CENTER for SCIENCE in PUBLIC PARTICIPATION

Re: NI 43-101 Technical Report on the Rovina Valley Project in Romania

Summary Comments

Figure 16.29: Rovina Pit and Co-Disposal Storage Facilities and Stockpiles

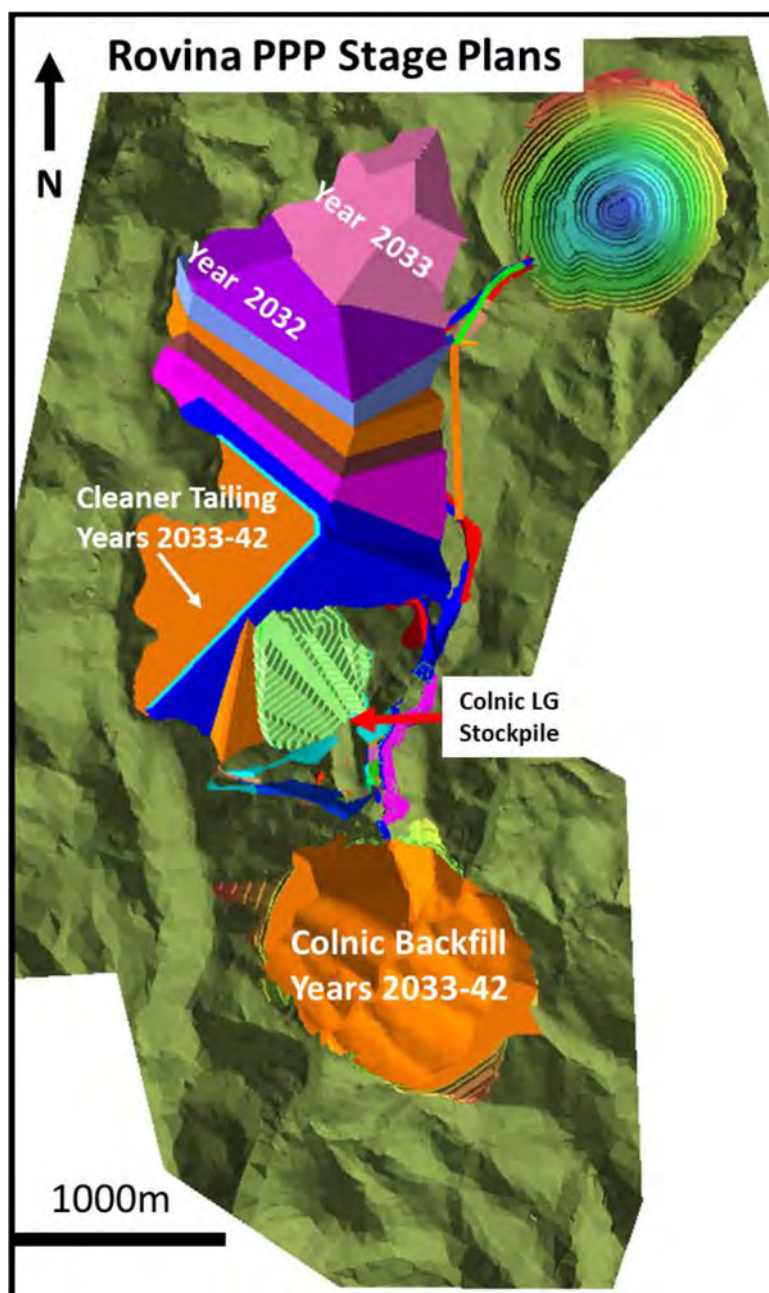
Although no cross sections are provided for the Cleaner Tailings Cell, it is obvious that the tailings will be restrained by upstream-type construction. There are no cross sections to show the design of the waste dumps, or the relative thicknesses of the "shells" providing structural support. Because of the limited

amount of space available for waste disposal, the slope of this facility will be, of necessity, steep. Structures with steep slopes are more prone to failure than structures with shallow slopes.

Upstream-type construction carries the highest risk for failure of all dam construction types. Even though the cleaner tailings have been filtered, so are no longer saturated, but are still subject to re-saturation. If the entire Cleaner Tailings Facility were compacted to “*Achieve dilatant conditions throughout the tailings deposit ...*”, as recommended by the Independent Expert Engineering Investigation and Review Panel (Expert Panel 2015), the stability of the Cleaner Tailings Facility would be significantly enhanced.

As it is presently designed, with potentially contaminated waste rock in the dam/shell, and uncompacted waste internally, the Cleaner Tailings Facility poses significant long-term risk.
